**DEFENSE NUCLEAR FACILITIES  
SAFETY BOARD**

## Staff Issue Report

**SUBJECT:** Seismic Qualification of Fire Suppression System at the Plutonium Facility, Los Alamos National Laboratory

**Figure 1: Example of fire suppression piping underneath unsecured equipment.**

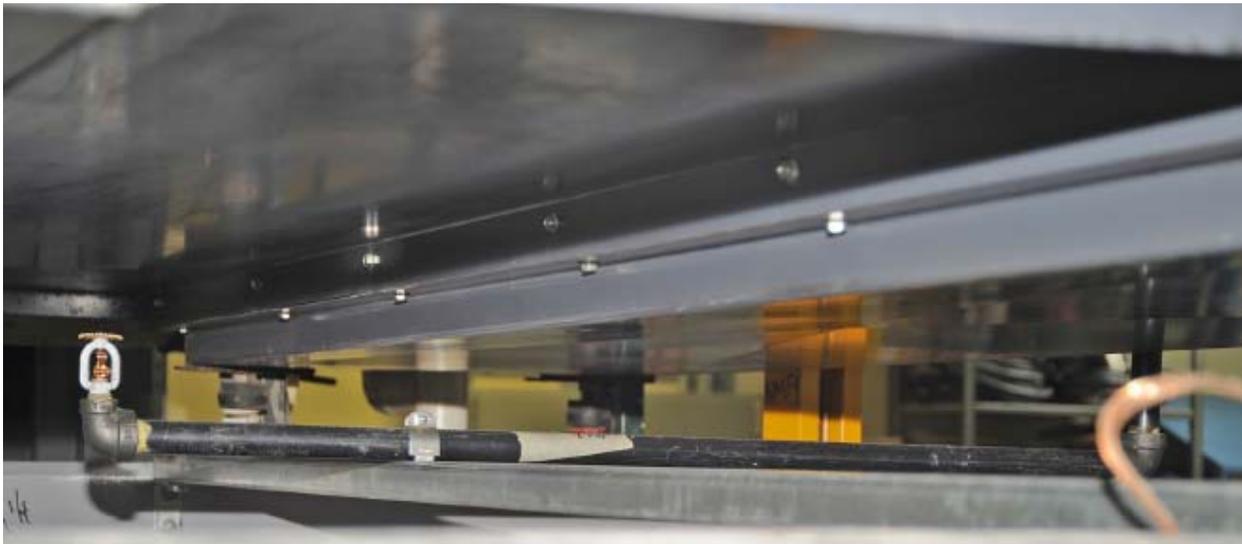
During the November 30, 2015, walkdowns, the staff review team found that a number of the seismic interaction concerns identified by LANS in 2010 still existed [5]. Most notably, large air handlers were installed above fire suppression piping without adequate seismic anchorage and bracing (Figure 1). Damage to the fire suppression piping from falling equipment, such as these air handlers, would lead to a loss of water and hydraulic pressure in the facility, impairing its function after a seismic event. The site's structural engineers could not provide the staff review team with a technical justification for why this condition does not pose a seismic interaction concern. They acknowledged that not all seismic interaction effects have been dispositioned for the FSS.
